IFB No. 16-39 West Middle School HVAC and Electrical Replacement

RE: ADDENDUM NO. 3

PROJECT: WEST MIDDLE SCHOOL
HVAC AND ELECTRICAL RENOVATIONS
ROCKFORD PUBLIC SCHOOLS 205
ROCKFORD, ILLINOIS

PROJECT NO.: 25107

PARTIAL BOILER ROOM HVAC PLAN

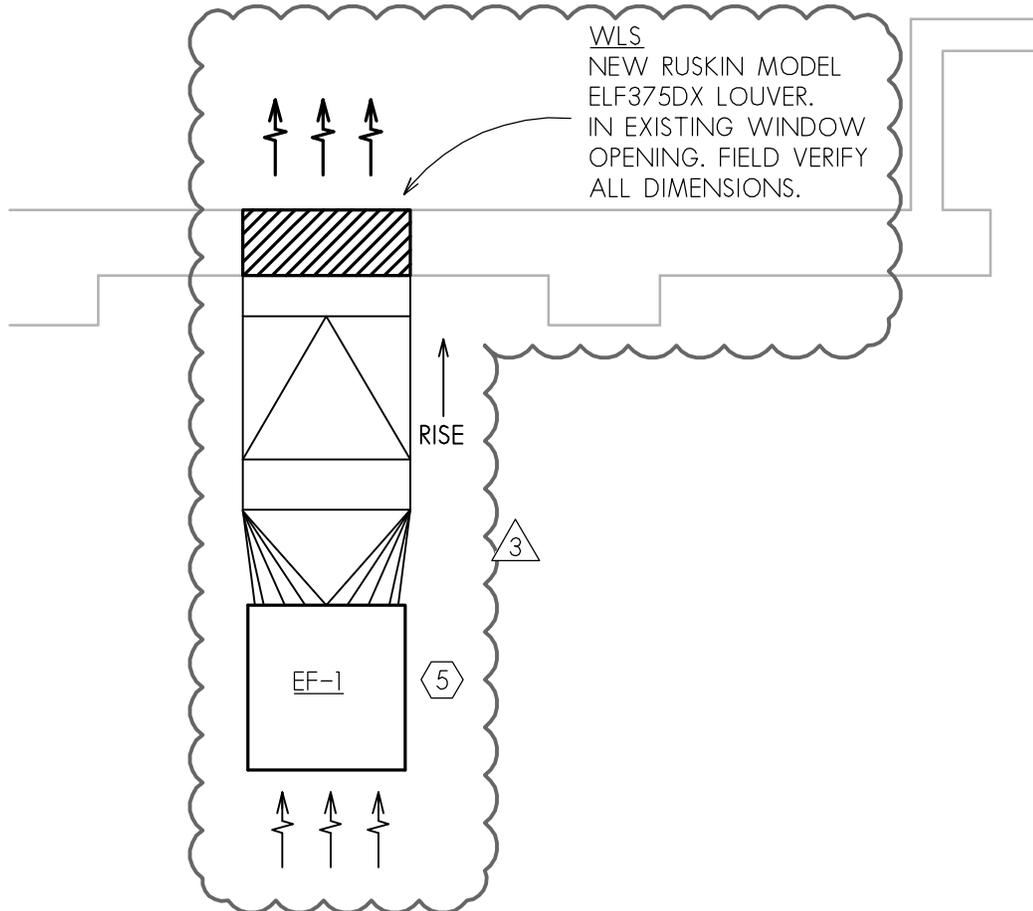
- a. Refer to attached Sketch M12-1 showing the revised boiler room summer ventilation exhaust fan EF-1 and associated ductwork.
- F. DRAWING M3.1
- a. Refer to attached Sketch M31-2 showing the revised Exhaust Fan Schedule.

5 INSTALL NEW EXHAUST FAN & 42X24 E/A DUCT TO NEW LOUVER AS SHOWN. PROVIDE INLET GUARD AT FAN. FIELD VERIFY ALL MEASUREMENTS. 3

1 ELECTRICAL ROOM DETAIL

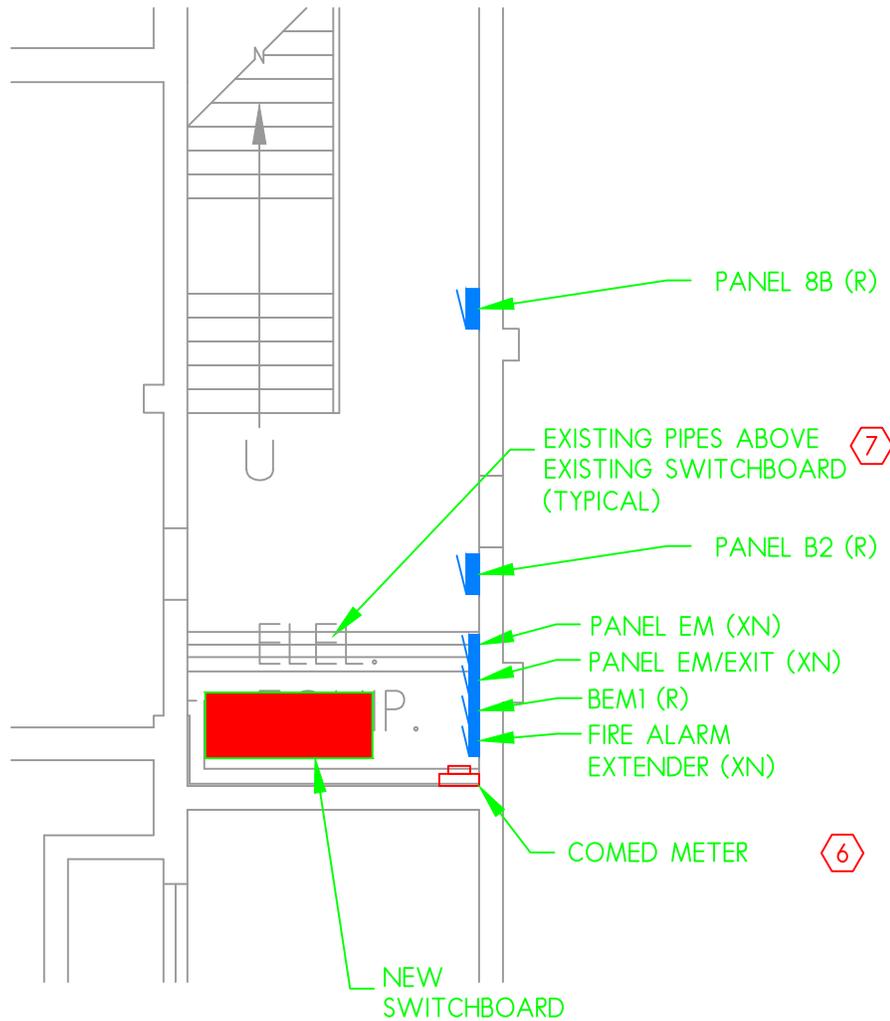
- a. Refer to Detail 1 reading "Electrical Room Layout". Presently there is a fire alarm extender box and three fire alarm system boxes in northwest corner of this room. Relocate them in new location on southwest side of this room. Presently, there are two electrical panels (Panel "EM" and Panel "EM/EXIT") located in northwest corner of this room. Relocate them in southwest corner of this room. Remove existing ComEd meter located in northwest corner of this room. Provide new ComEd meter in

southwest corner. New switchboard to be located on north side rather than south side. Refer to attached sketch SE-E1.0.
